ADDENDUM NO. 2

Invitation to Bid (ITB) 26-17-214505

Whittier Yard Drain Repairs Phase 1 Construction

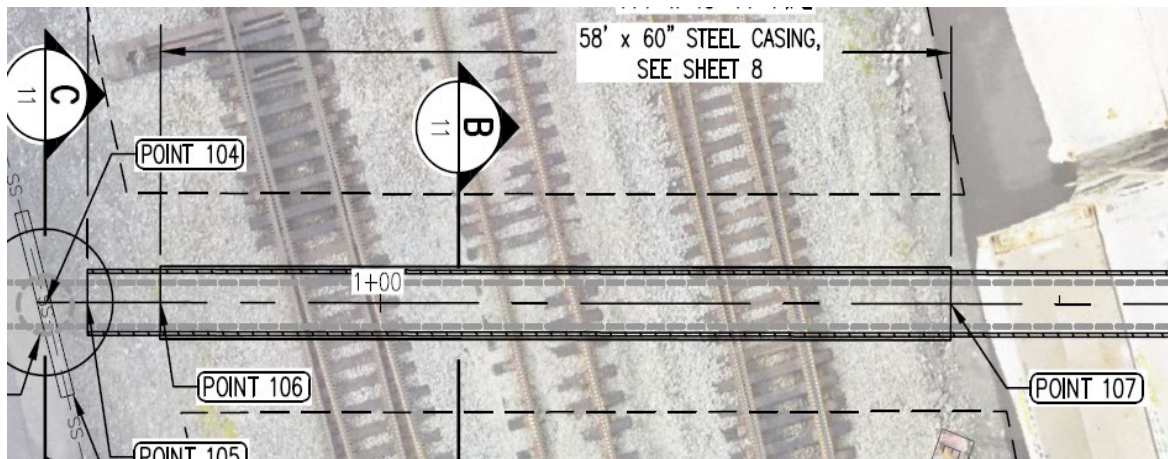
1. Can Is the 58' long section of 60" steel casing shown below intended to be one piece? If not, are there specifications/procedures for joining multiple pieces of 60" steel casing via welding or other approved methods?

Yes, the intent is for it to be one piece. The pipe may be joined by welding, unless alternative equivalent method is submitted by the contractor and approved by ARRC, prior to implementation.
